### WATER OAK APARTMENTS

12,125 S IH 35, AUSTIN, TX 78747 SP-2019-0109C Pamela Abee-Taulli

Environmental Program Coordinator

Development Services Department

Arrow shows area of 25' fill.

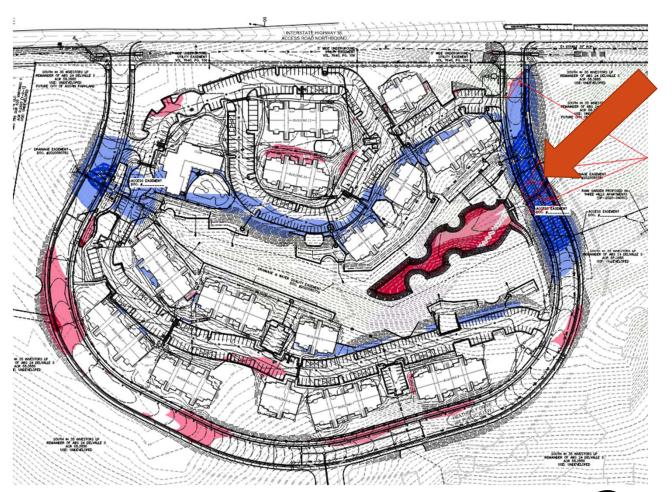
Roadway is partially completed.
